DRAWING TITLE
LEVEL ONE EAST - HEATING & AIR CONDITIONING

PROJECT TITLE
TERRITORIAL ADMINISTRATION BUILDING
WHITEHORSE, Y.T.

REVISIONS TO LAYOUT DUE TO PARTITION CHANGES

STEAM PIPING SCHEMATIC N.T.S.

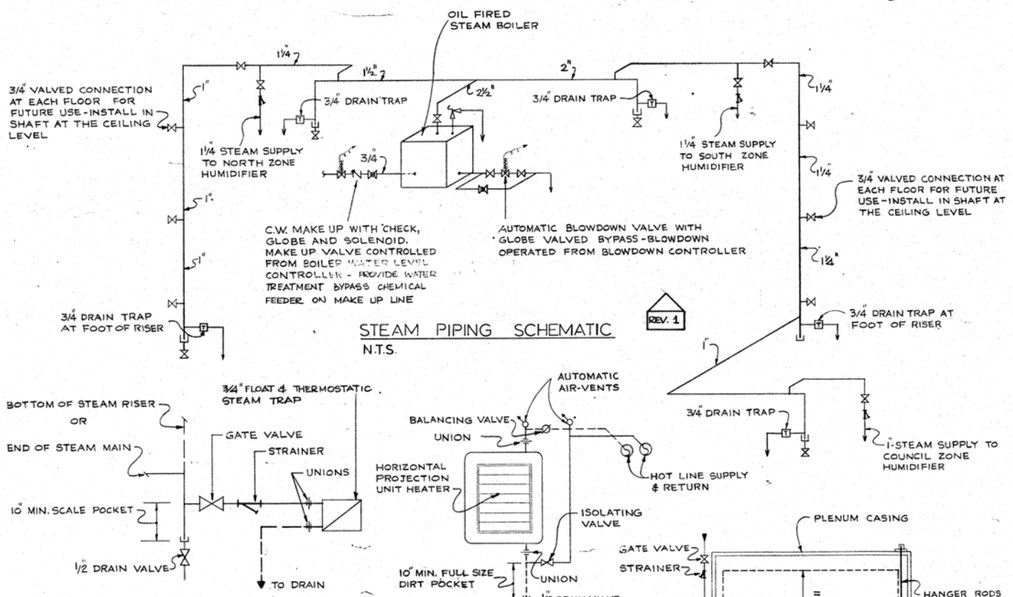
REVISIONS			
NO.	DATE	DESCRIPTION	
1	30 AUG 74	ADD. A STEAM PIPING SCHEMATIC. PIPE SIZES REVISED	
2	30 AUG 74	ADD. B TYPICAL FLASHING-2, BACKDRAFT DAMPER LOCATION REVISED
